STATE HISTORIC PRESERVATION OFFICE (SHPO) QUESTIONS & RESPONSES

Fort Apache Home of Harmony Project

March 13, 2024

This Addendum includes Architect's responses to SHPO questions pursuant to Historic Tax Credit (HTC) grant award. These questions have minor effect on the drawings and were not included in during the bidding process to avoid conflict and/or confusion with addendums that directly related to bidding/pricing. Some of these questions necessitated specific drawing revisions, which were issued with the following narrative responses. These questions and answers, along with revised sheets, are being memorialized as ADDENDUM #9, and affected sheets / Specification Pages are included in the Construction Document Issuance hereafter. While it is not anticipated that these changes have cost implications, the Contractor shall alert the Architect and Owner in the event they do.

3 BUILDING SECTION
SCALE: 3/16" = 1'-0"

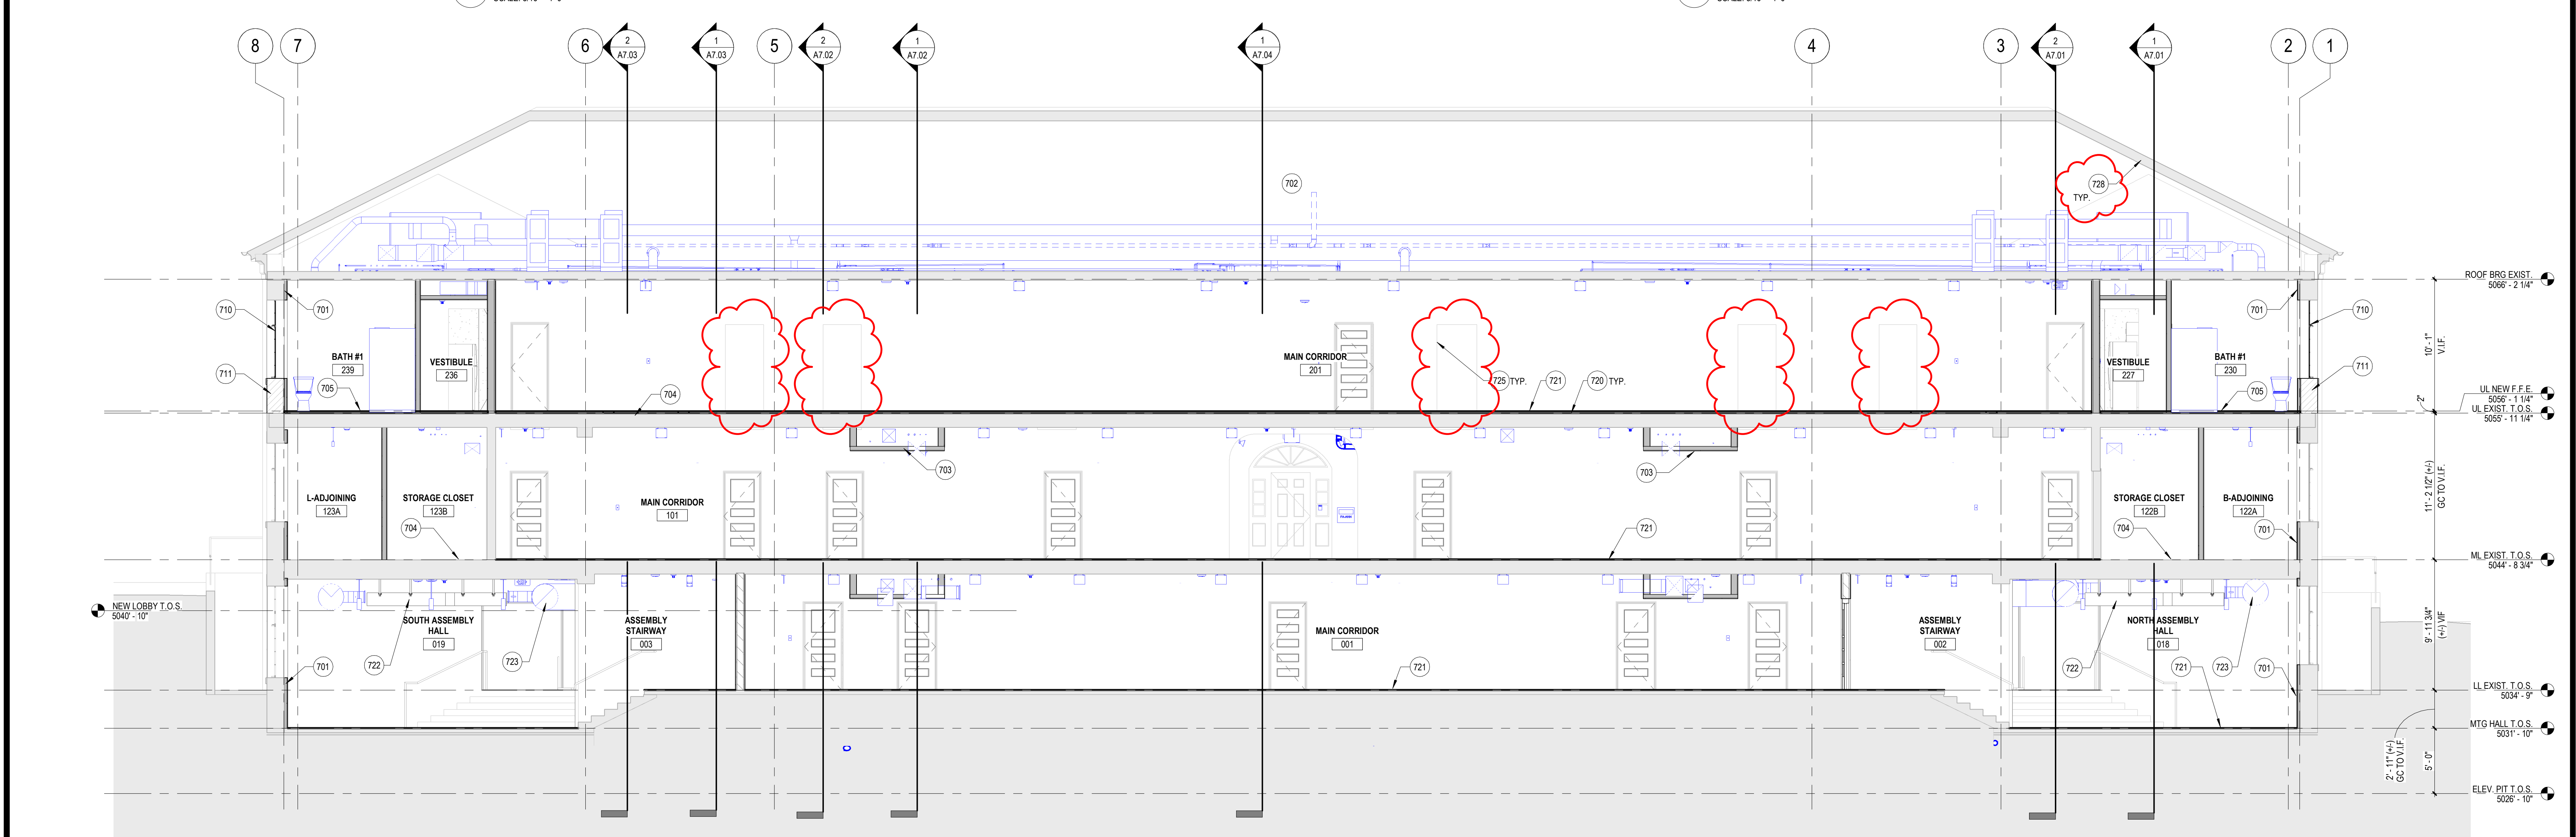
On Sheet A7.01, is attic equipment in front of window?

The two existing half-round louvered opening in the gable ends to be retained and utilized for mechanical ventilation. Additional keynote added to this building section.
